DEVELOPMENT REVIEW BOARD REPORT

53-DR-2006
SGA Hangars

Request for approval of a site plan and elevations for a new hangar/office building.

Stipulations for Case:
Case Name
Case 53-DR-2006

ATTACHMENT #4

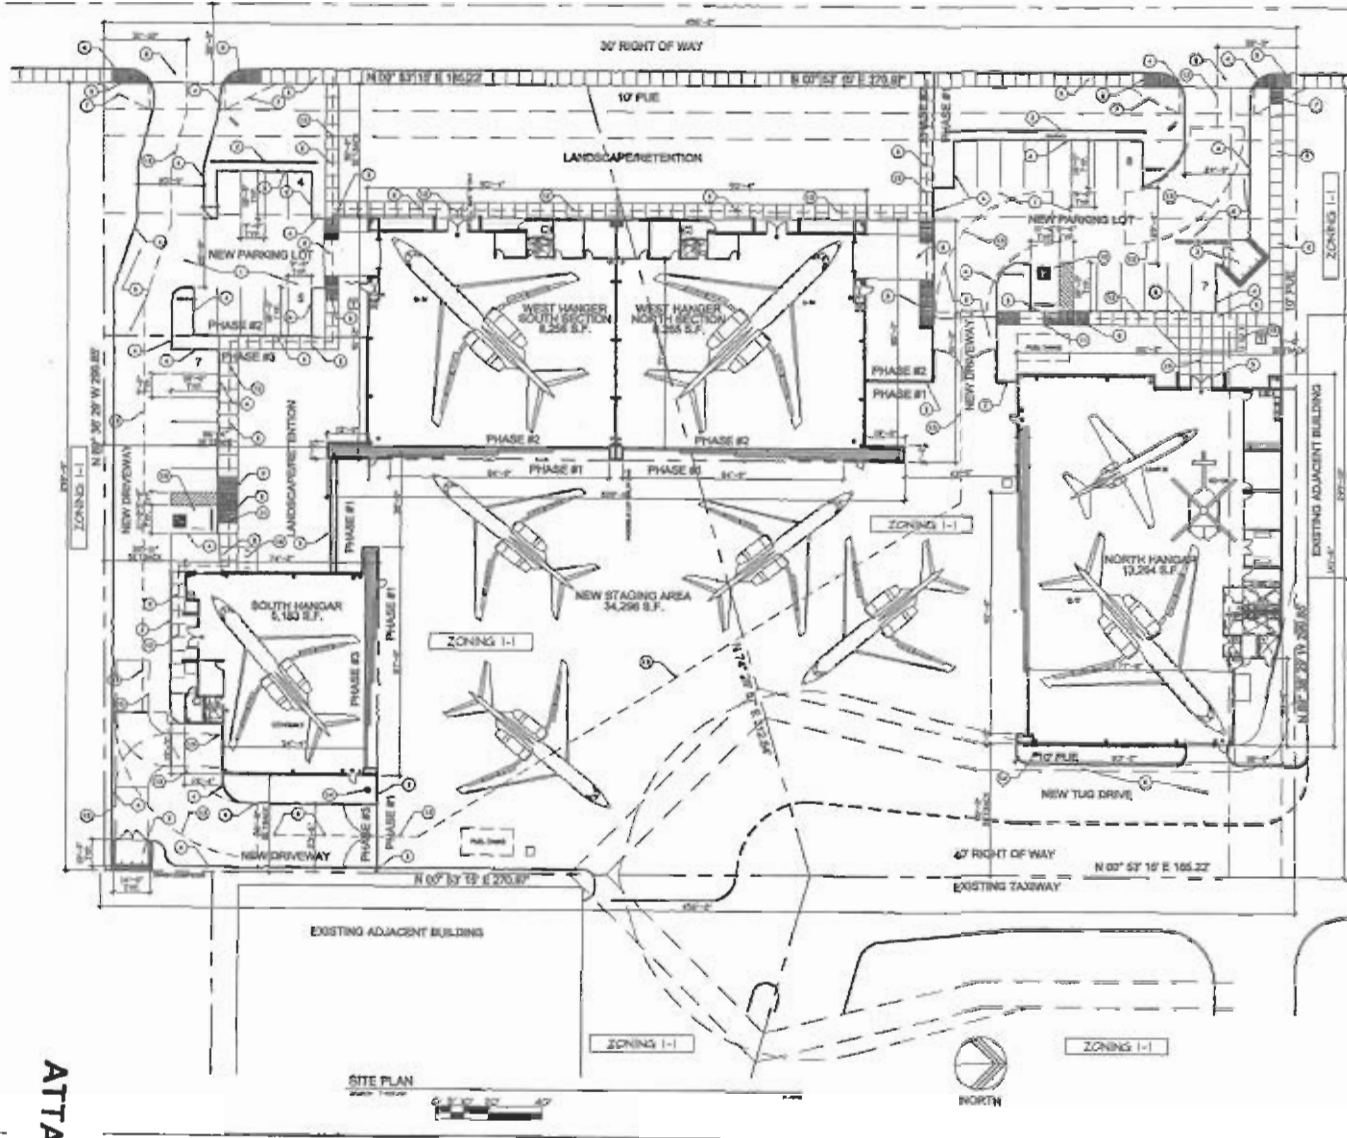
13. *Prior to or concurrent with the final plans submittal the developer shall submit for a Land Assemblage Application.*
14. *Prior to or concurrent with the final plans submittal the developer shall submit for a Release of Easement Application to release the Ingress/Egress easement that encroaches into the north hangar.*

16. *At time of final plans provide letter from utility company accepting the proposed location of the mechanical equipment and screening.*
17. *Retention should be calculated to show that the square footage within the front open space is less than 50%.*

45. The developer is proposing to install two refuse enclosures for this site. The configuration for the single refuse enclosure closest to 78th Street is satisfactory. The location and configuration of the proposed single refuse enclosures in the rear portion of the site is not acceptable. With this configuration, the refuse trucks have no space to turn around, since they cannot use the tarmac/taxiway. Hammerhead turnarounds are not permitted, unless written approval is received from Mark Powell in the City of Scottsdale Commercial Sanitation Division. The final improvement site plan shall provide proper space to turn around the refuse trucks.

SOUTH ELEVATION - ENTIRE SITE

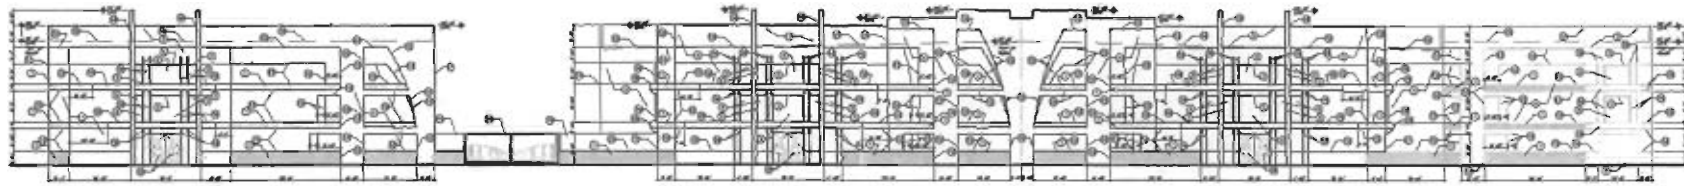
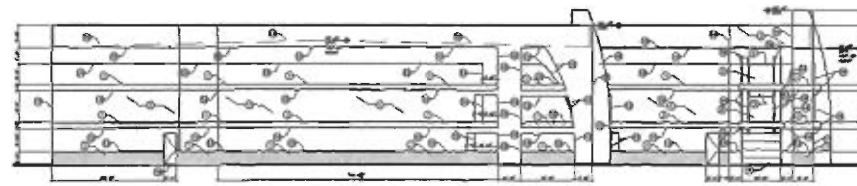
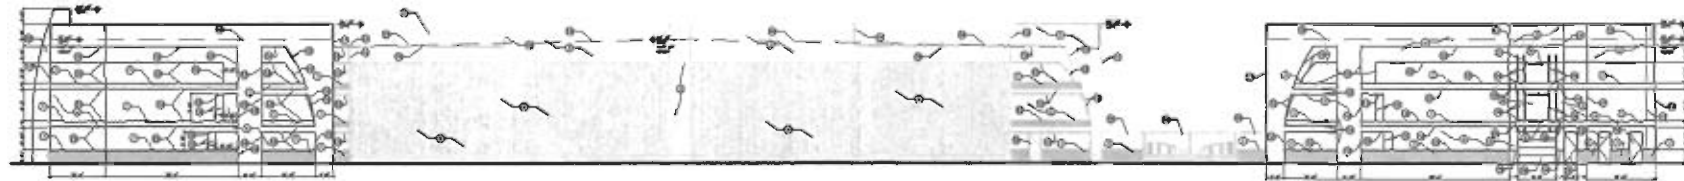
3. *At time of final plans the elevations shall be revised to show the building height analysis for each building.*
4. The face of the service entrance section(s) shall be flush with the building façade and painted to match the building.
